Re: **Canadian Renewable Energy Corporation Application for
Leave to Construct Transmission Facilities (EB-2007-0034)**

**THE INDEPENDENT ELECTRICITY SYSTEM OPERATOR
IN RESPECT OF PROCEDURAL ORDER NO. 3**

System Impact Assessment Report

**Wolfe Island
Wind Generation Station (WGS)**

Figure 1: Standards for Setting Under-frequency Trip Protection for Generators

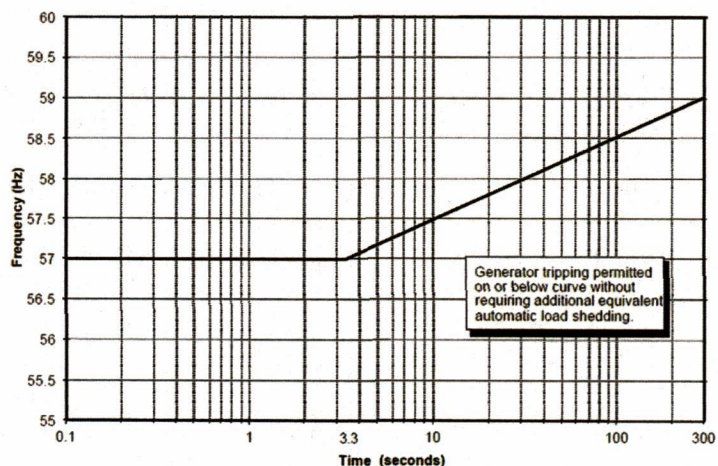
- (14) The generator under-frequency settings should be set such that the generators do not trip for frequency variations that are above the curve in Figure 1.

3. The facility must be capable of operating at full active power for a limited period of time for frequencies as low as 58.8 Hz. The wind turbine generators must not trip for under-frequency system conditions that are below 60 Hz but above 57.0 Hz and above the curve shown in Figure 1.

FIGURE 4 – VARIATION OF Q_{MAX} AND Q_{MIN} WITH TERMINAL VOLTAGE

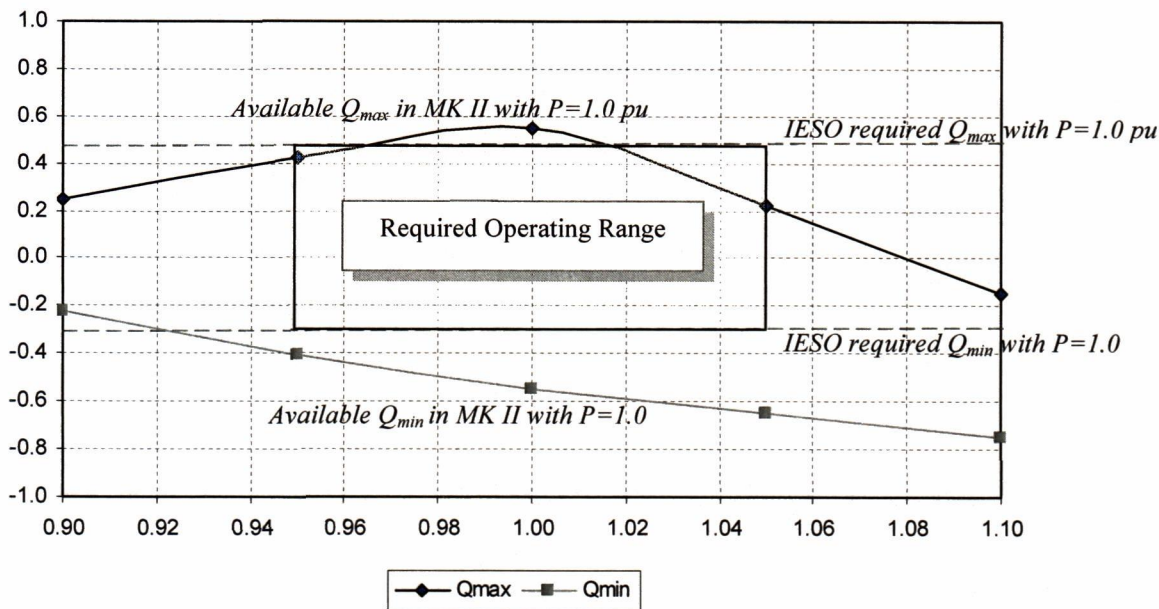
It can be seen that if the rated voltage is 1.0 pu, at the extremes of the $\pm 5\%$ voltage range, the generator can deliver only $Q_{max} = 0.42$ pu (at 0.95 pu voltage) and $Q_{max} = 0.22$ pu (at 1.05 pu voltage). That would mean each MK II generator can be short of delivering $0.47 - 0.22 = 0.25$ pu or $0.25 \times 2.3 = 0.575$ MVar of required dynamic reactive power. As far as the entire wind farm is concerned, it can be short of delivering $0.575 \times 86 = 49$ MVar of required dynamic reactive power. Conversely, the MK II can absorb $Q_{min} = 0.41$ pu (at 0.95 pu voltage) and $Q_{min} = 0.65$ pu (at 1.05 pu voltage). That would mean each MK II has the capability to absorb excess reactive power than the amount required by the IESO.

It was evident from the Figure 4 of the Section 6.1.2, that if the MK II is operated at 1.0 pu as nominal voltage, the generator is not able to supply the IESO required level of reactive power near the extremes of the $\pm 5\%$ voltage range. This will impose a requirement to have an extra dynamic reactive power source to compensate for above deficiency. As an alternative solution, it can be seen from Figure 5 that if the nominal operating voltage is reduced to 0.975 pu and the generator produces only up to 0.97 pu active power, the generator could largely meet the IESO requirement on reactive power capability without having any extra dynamic reactive power source.

- (a) the generator must be nominally operated at 673 V
- (b) the maximum power output should be 2.23 MW
- (b) the generator must be able to continuously produce 2.23 MW within 639-706 V range

FIGURE 6 – QV CURVE FOR GARDINER 230 kV BUS

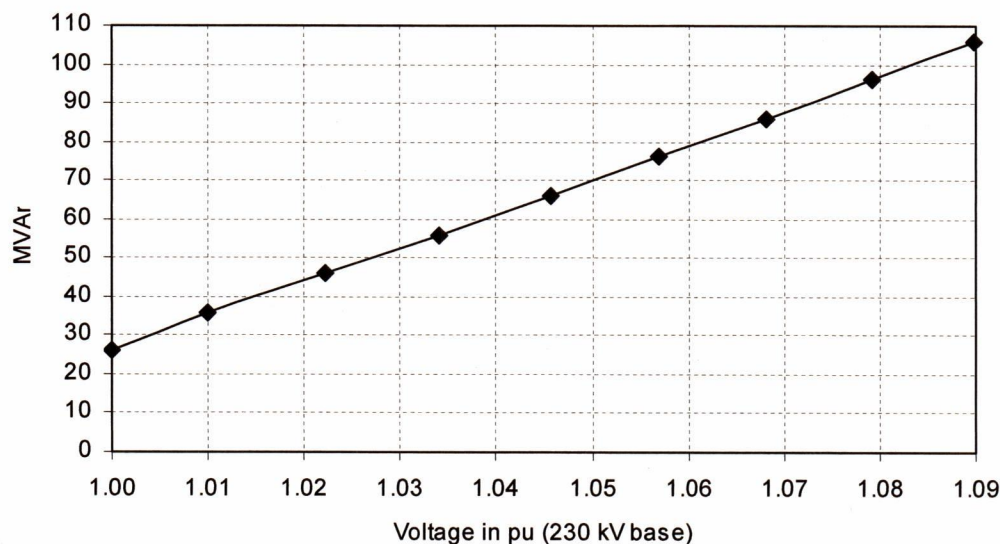
However, often the Gardiner voltage is more than 230 kV and can be as high as 245 kV at times. If that level of voltage is to be maintained by the wind farm, more than 26 MVar compensation must be added to the 230 kV bus. The additional compensation is calculated using QV analysis. Figure 6 shows the QV curve for the Gardiner 230 kV bus. This graph demonstrates the variation of the voltage with additional reactive power injected into 230 kV bus.

If the voltage reaches 245 kV or 1.07 pu, approximately 85 MVar of compensation would be required at 230 kV bus so that the wind farm could maintain that voltage. If not, the wind farm would draw reactive power from the grid. Instead to the 230 kV bus, the compensation can be provided to the collector buses if an added compensation is provided to supply losses occurring in the 230 kV cables and two 34.5/230 kV transformers. These losses appear to be about 10 - 15 MVar depends on the operating condition. Thus, the IESO requires 50 MVar to be provided at each collector bus and be supplied in 5 steps of 10 MVar.
